IREDELL COUNTY HEALTH DEPARTMENT

IMPROVEMENT PERMIT / AUTHORIZATION TO CONSTRUCT / OPERATION PERMIT / EXISTING SYSTEM INSPECTION

PERMIT# 095638 PIN# 4776 52 2526 DATE 5-18-01

INITIAL SITE SKETCH

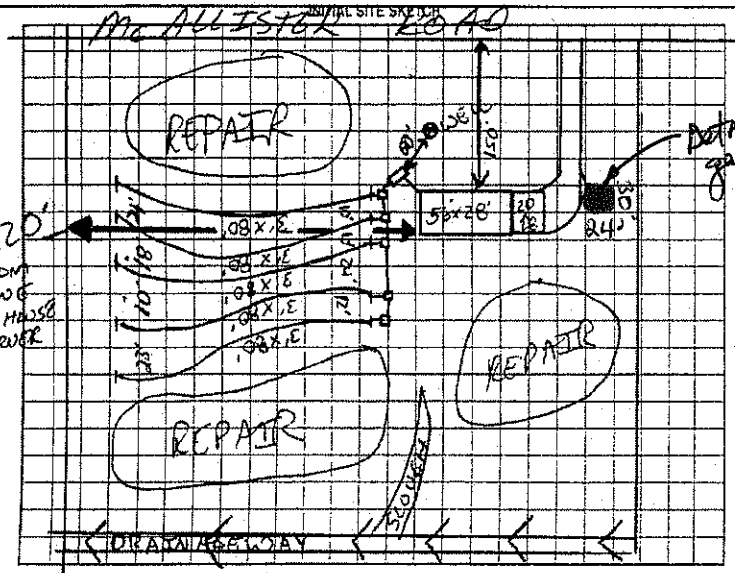
Comments/Conditions: ① INSTALL LINES ON CONTOUR AS FLAGGED OUT ② MAINTAIN SETBACKS

AS BUILT SKETCH

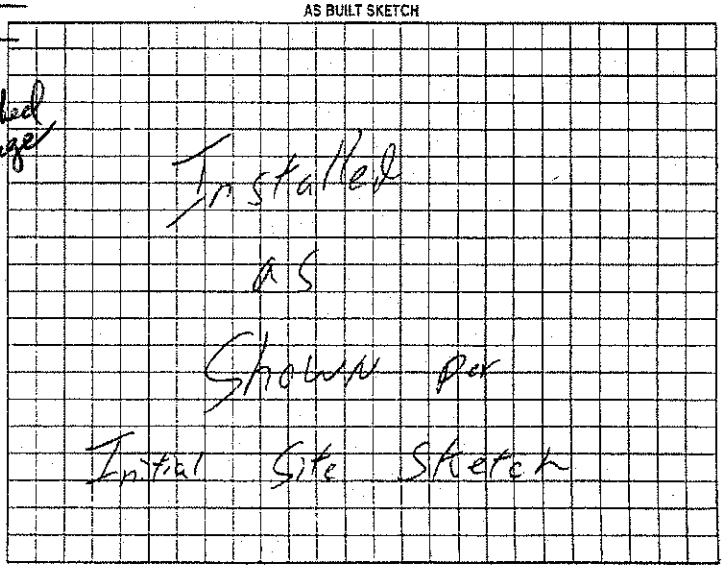
Comments/Conditions -Poly Lok Filter Installed
- Septic Tank Liner Installed

Location of the proposed 24X30' detached garage addition does not appear to impact the existing on-site septic system.NOTE:**
